NUREG/CR-5347
BNL-NUREG-52191

Recommendations for Resolution of Public Comments on USI A-40, “Seismic Design Criteria”

Recommendations for Resolution of Public Comments on USI A-40, “Seismic Design Criteria”

Manuscript Completed: February 1989
Date Published: May 1989

Figure 12. PSD OBTAINED FROM CLIPPED VERSUS NON-CLIPPED TIME HISTORIES

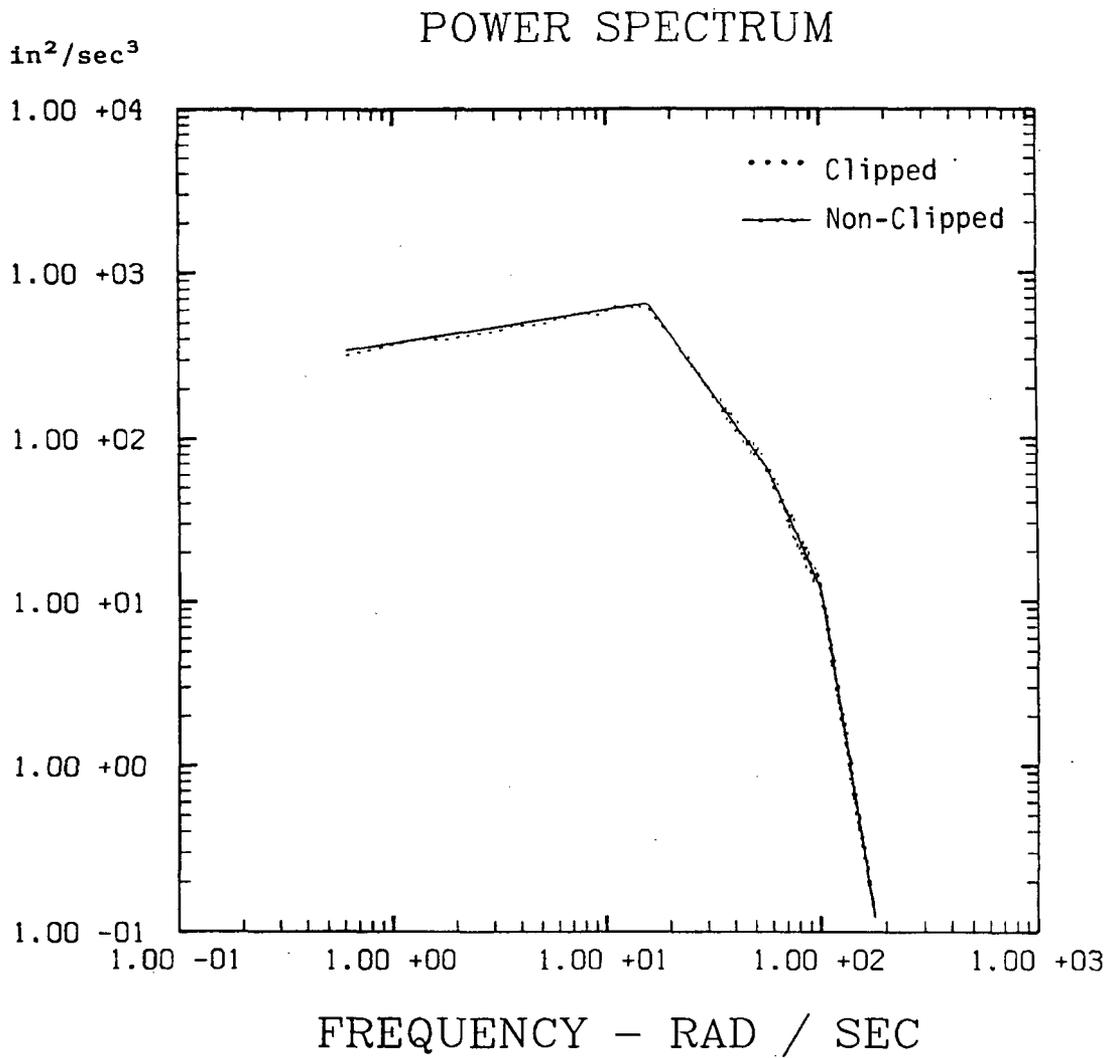
Figure 12 shows the resulting PSD obtained when the time history shown in Figure 10 based on PSD 3 has the one peak which exceeds 1.0g clipped at 1.0g. Figures 13 and 14 show the 2% damped PSRV response spectrum obtained when the time histories are clipped at 1.0g. Note that the exceedances of the RG 1.60 Response Spectrum above 23 Hz have now disappeared.
